Application No.	Applicant(s)	
Notice of Allowability	09/944,657	FENG, XIAO-FAN	
	Examiner	Art Unit	
	Cheukfan Lee	2622	
The MAILING DATE of this communication apperature All claims being allowable, PROSECUTION ON THE MERITS IS herewith (or previously mailed), a Notice of Allowance (PTOL-85) NOTICE OF ALLOWABILITY IS NOT A GRANT OF PATENT RI of the Office or upon petition by the applicant. See 37 CFR 1.313	(OR REMAINS) CLOSED in or other appropriate comm GHTS. This application is and MPEP 1308.	n this application. If not included unication will be mailed in due course. THIS	tive

Application/Control Number: 09/944,657 Page 2

FIG. 1 -- PRIOR ART --

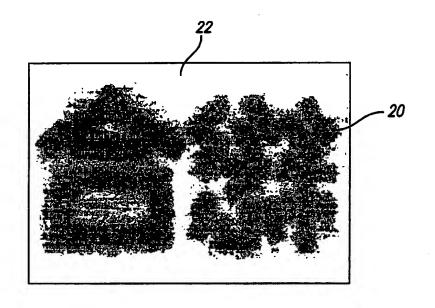
drawings by labeling Figs. 1-6 with "PRIOR ART" as requested in the previous Office

Label Figs. 1-6 with – PRIOR ART --.
